Access Compliance Report

Public Rights-of-Way

(Curb Ramps)

Intersection ID: 27626	Main Street: FLORAL_HALL_DR	Cross Street: JAMES JACK_LN	Location: SW
ADA ID: 132E69D03187	Ramp Type: BlendTrans2	Initial Pass/Fail: Fail	Overall Compliance: No
Severity Score: 10			
Codes/Mitigation Info/Possible Solution		Field Measurements/Component Compliance

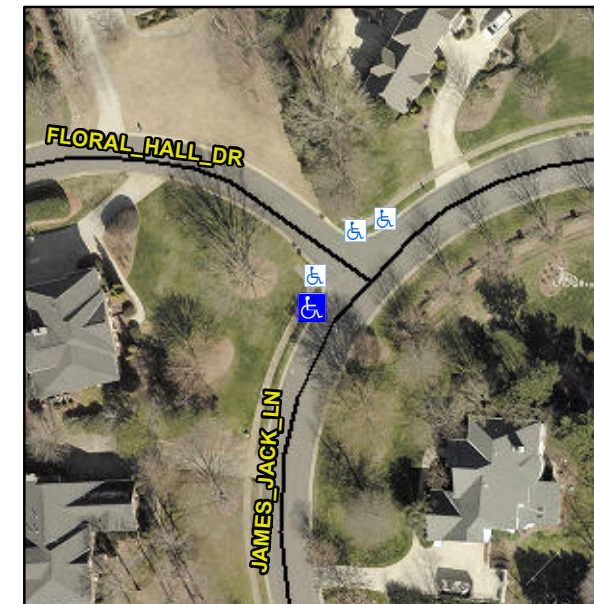
Not Found, R304.5.1, R304.5.3

Compliance	Description	Data	Compliance	Description	Data
N/A	Ramp Length (in)	53.0	Yes	BlendTrans Slope (%)	1.6
No	Ramp Width (in)	43.0	No	BlendTrans XSlope (%)	2.8
N/A	Flare Type LT	N/A	N/A	Flare Type RT	N/A
N/A	Flare Slope LT (%)	N/A	N/A	Flare Slope RT (%)	N/A
N/A	Flare Traversable LT?	N/A	N/A	Flare Traversable RT?	N/A
N/A	Landing Length (in)	N/A	N/A	DWS Provided?	N/A
N/A	Landing Width (in)	N/A	N/A	DWS Contrast?	N/A
N/A	Landing Slope (%)	N/A	N/A	DWS Length (in)	N/A
N/A	Landing X Slope (%)	N/A	N/A	DWS Full Width?	N/A
N/A	Landing Curb? (Y/N)	N/A	N/A	DWS Offset (in)	N/A
N/A	Shared Landing?	N/A			
N/A	Gutter Ponding?	N/A	N/A	Gutter Slope (%)	N/A
N/A	Gutter Lip Ht (in)	N/A	N/A	Gutter X Slope (%)	N/A
N/A	Painted X Walk1?	No	N/A	Painted X Walk2?	N/A
	X Walk 1 Direction	To SE		X Walk 2 Direction	N/A
	X Walk 1 Width (in)	N/A		X Walk 2 Width (in)	N/A
	X Walk 1 Slope (%)	0.4		X Walk 2 Slope (%)	N/A
	X Walk 1 X Slope (%)	0.6		X Walk 2 X Slope (%)	N/A

N/A	Ramp inside XWalk1?	N/A	N/A	Ramp inside XWalk2?	N/A
	Road Slope (%)	0.6		Clear Space?	N/A
	Road X Slope (%)	0.4	N/A	Clear Space to XWalk (in)	N/A
N/A	Any Obstructions?	N/A	N/A	Storm Grate/Utility Hazard?	N/A
	Obstruction Type			Storm Grate/Utility Type	
		N/A			N/A
			Yes	Surface Condition? (G/P)	Good
			No	Curb Slope (%)	21.8

Remove & Replace Curb Ramp With Two New Directional Ramps or Equivalent.
